**Planning & Zoning Commission Agenda
Rochester Boards & Commissions - Planning & Zoning Commission
August 23, 2023
6:00 p.m.**

5.A. [Major Land Subdivision No. CD2023-009PLAT by Pine South West, to be known as Ponderosa Pine](#)

5.B. [Major Land Subdivision No. CD2023-011PLAT by Hawk Ridge Development LLC, to be known as Hawk Ridge South](#)

6.A. Zoning Map Amendment No. CD2023-007ZC by Farmland LLC (Mercy Hill)

HAWK RIDGE SOUTH
PRELIMINARY PLAT

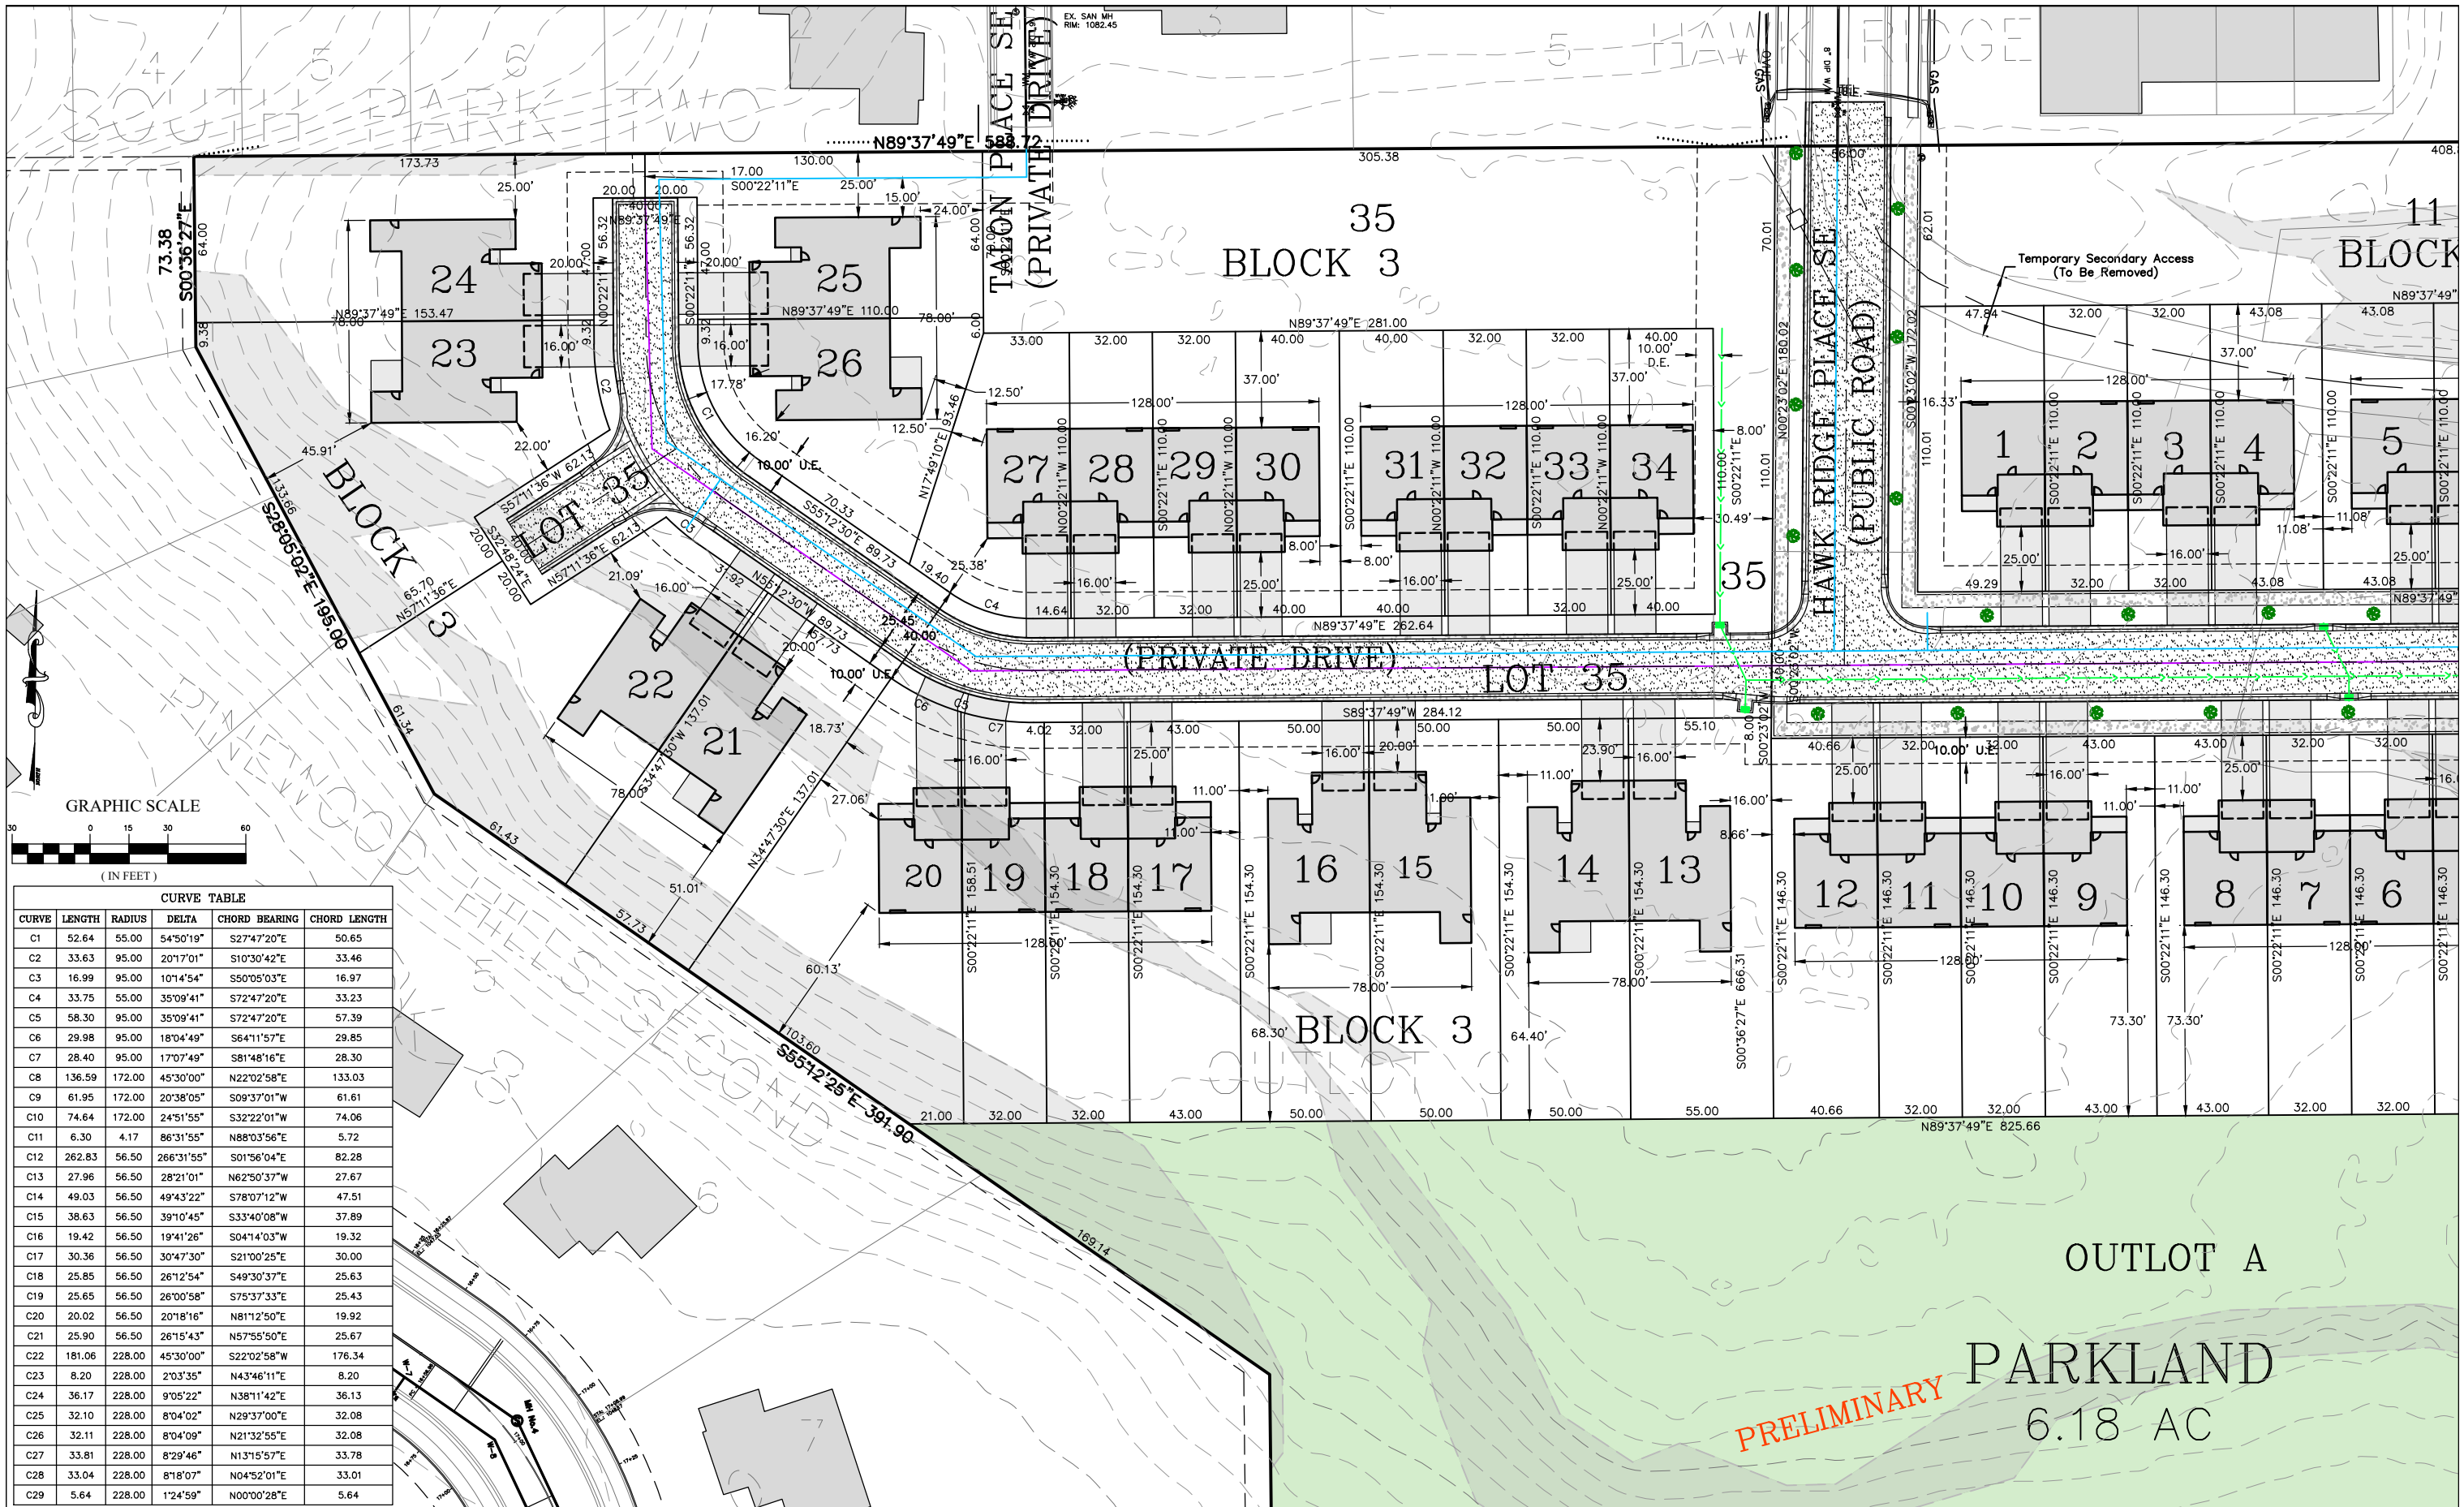
The current plat shows proposed parkland of 6.18 Acres total in outlot A. Please verify on the plat that the following information from the GDP exists in outlot A:
